Response to An Bord Pleanála Opinion relating to Item 1, 2 and 12

Strategic Housing Development (Reg. Ref ABP-311304-21)

Barrington Tower SHD, Brennanstown Road, Dublin 18

April 2022

Figure 1 – Brennanstown Road – Upgrade works completed as part of the Brennanstown Wood Development

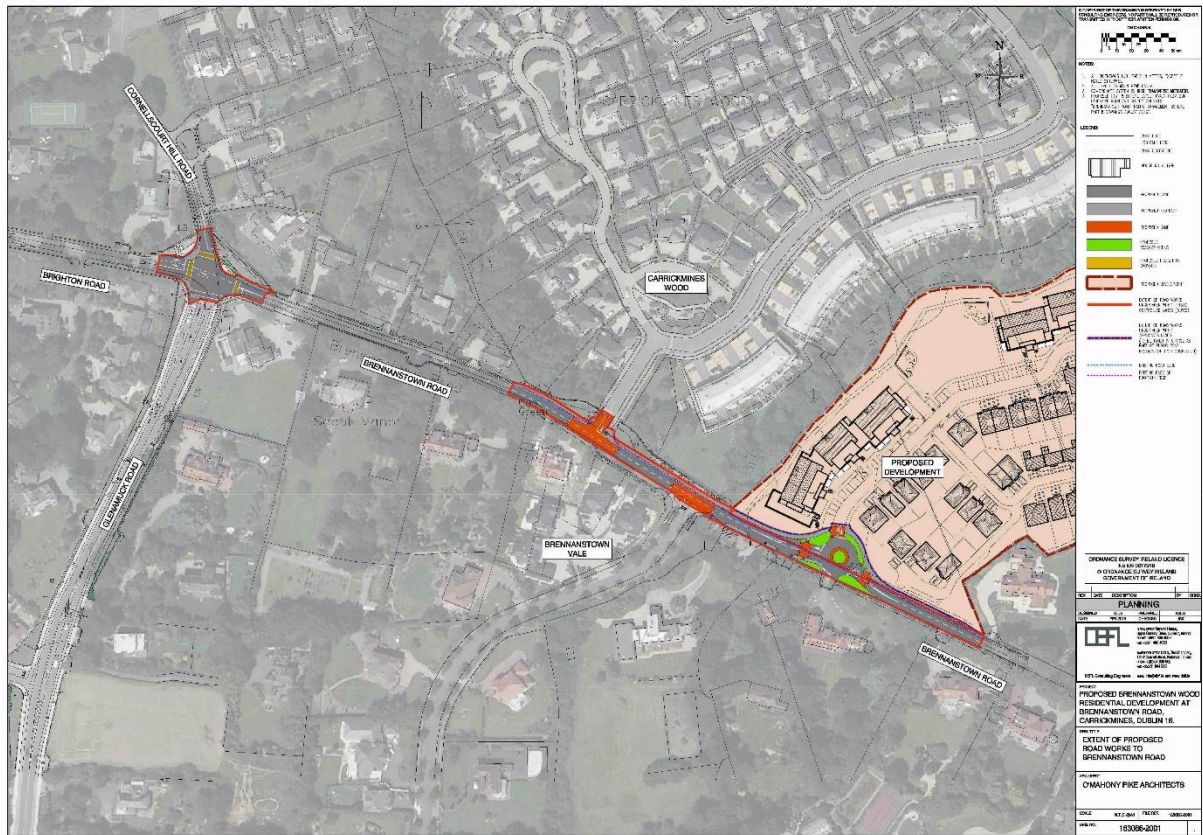
A detailed statement, demonstrating how the proposed development will tie in safely with the wider road network, for the overall Brennanstown Road area, in particular the Brennanstown Wood development to the north west, and the future LUAS stop to the south, with regard to vehicular, pedestrian and cycle connections.

the main pedestrian route from site will be to the west towards the Brennanstown Wood development. Brennanstown Wood is a recently completed development and as part of the Brennanstown Wood development a section of the Brennanstown Road has been upgraded including the provision of a new roundabout at the main access to the development. The upgrade included a new footpath which ties into the existing footpath infrastructure along Brennanstown Road, to the east and west.

Details of the upgrade works are shown in Figure 1 below:-

Figure 2 – Extract from Drawing No 20-040/P017

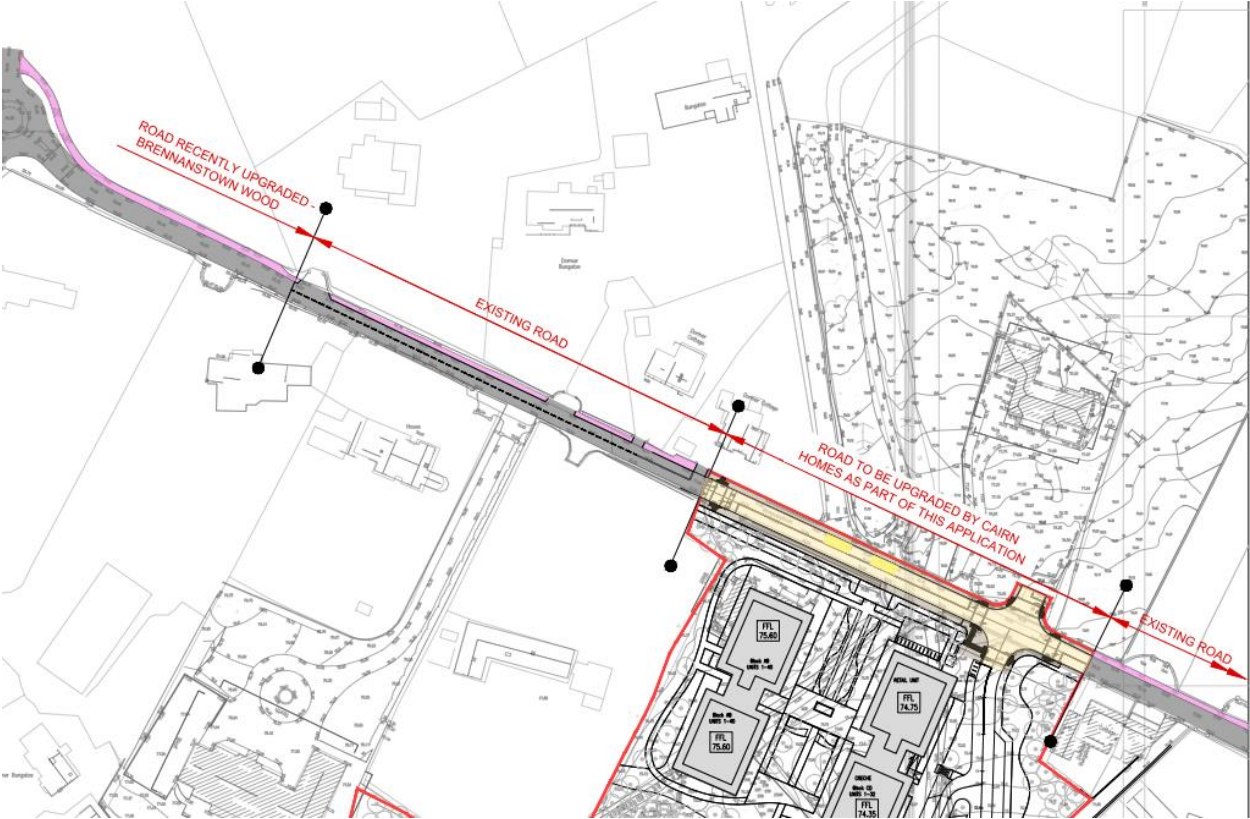
A detailed statement, with accompanying plans and drawings, setting out in detail, adequate, safe traffic / pedestrian facilities on Brennanstown Road to accommodate the scale and quantum of development proposed.

Figure 2 below, which is an extract from our enclosed Drawing No. 20-040/P017, shows the location of the proposed new footpath, raised signalised crossing and signal controlled junction together with the existing upgraded footpath completed as part of the Brennanstown Wood development.

The drawing extract in Figure 2 shows that we will have a relatively short section of existing footpath (approximately 130m) which provides connectivity between our proposed new footpath and the existing footpath. The existing footpath which we are relying upon for the connectivity was proposed to be retained within Dun Laoghaire Rathdown County Councils (DLRCC) Part 8 proposals that they prepared for the Brennanstown Road upgrade.

Please refer to Item 1 above together with our enclosed drawing no. 20-040/P017 which shows how the proposed development will tie into the existing infrastructure. Please also refer to our Drawing No. 20-040/P014 which provides details for the proposed upgrade works to Brennanstown Road that are included with the current application. This includes a new 2m footpath along the site frontage, a new signalised junction with pedestrian phasing to provide connectivity to the existing footpath on the north side of Brennanstown Road together with a new raised table and signalised pedestrian crossing on the western boundary providing connectivity also to the footpath on the north side of the road. The measures proposed will reduce traffic speed on Brennanstown Road and provide for safe traffic movements into and out of the proposed development.

Figure 5 – Location of Automatic Traffic Counters.

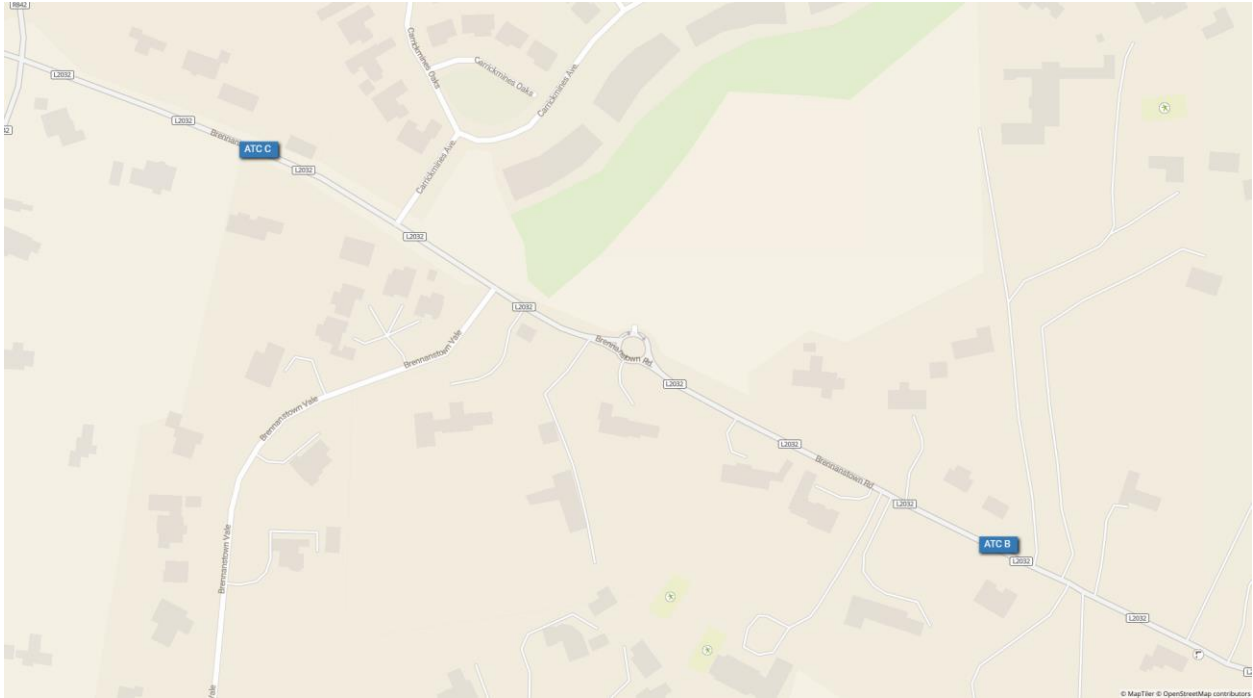
The speed of traffic travelling along Brennanstown Road was raised during the tri-partite meeting by An Bord Pleanála and it was noted that lower traffic speeds make the road a safer environment for pedestrian and cyclists. In this regard the provision of the pedestrian crossing on the raised table together with the signalised junction at the main access to the site will assist in reducing the current speed of traffic on Brennanstown Road.

The first location is in front of the subject site. This is identified in Figure 5 below as “ATC B”.

The second location is to the northwest of Brennanstown Wood and is identified in Figure 5 as “ATC C”.

The traffic speed survey showed that the average cumulative traffic speed (i.e. the average speed of traffic driving in both directions) recorded over 7 days along Brennanstown Road, in front of the subject site (at ATC B), was 45.52kph and the Cumulative 85th percentile speed was 53.55kph. The 85th percentile speed is the speed at or below which 85 percent of all vehicles are observed to travel under free-flowing conditions past a monitored point.

The average cumulative speed northwest of Brennanstown Wood, (ATC C) which was recorded over the 7 day period was 39.35kph and the 85th percentile speed was 46.72kph.

The surveyed location ATC C is within the area where Brennanstown Wood have undertaken upgrades on the public roads, which include raised tables at Brennanstown Vale and at Carrickmines Wood. The traffic speeds on this section of road are noticeably less with a 13.55% reduction in the cumulative average speed and 12.75% reduction on the 85th percentile speed.
